**Combined comments on the proposed amendments to the modification of the Cobaki Concept Approval (MP06\_0316 Mod 5) and the proposed modification of the Project Approval (MP08\_0200 Mod 4) with regard to water supply and waste water treatment.**

I refer to your email of 1 February 2017 requesting Council's comments on the proposed additional changes to the water services Mod to the Concept Plan and Project Approval.

Figure 3.1: Proposed Access Street Cross-Section

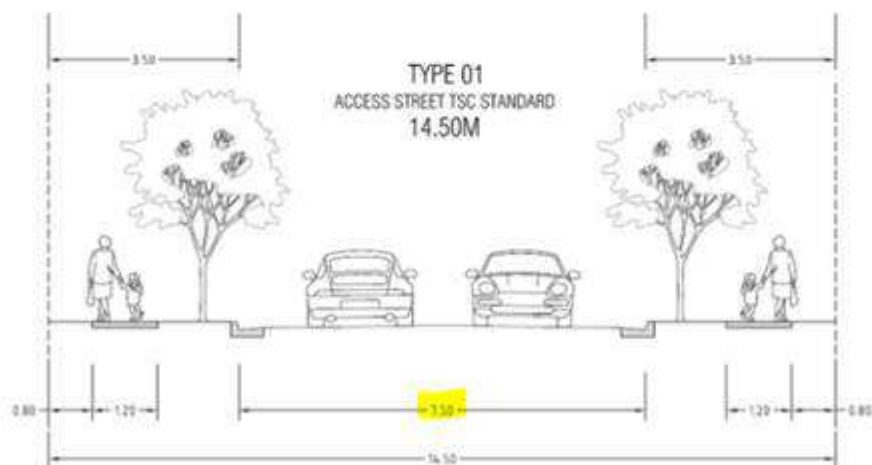
- a. Council's standard (and the current Development Code) specifies a 14.5m road reserve for Local Roads within Cobaki, consisting of 7.5m sealed pavement and 3.5m verges. The latest proposal widens the verge to 4.25m, but has maintained the same road reserve. This has reduced the road pavement to 6.0m, which is not supported.

This reduction is also inconsistent with the proponent's recently submitted Traffic Impact Assessment. Refer to the extract below from the Bitzios Traffic Impact Assessment.

If wider road verges are needed to accommodate the required services, then the road reserve needs to be widened and all plans amended accordingly to ensure consistency. This may impact on lot layouts for existing and future subdivision configurations.
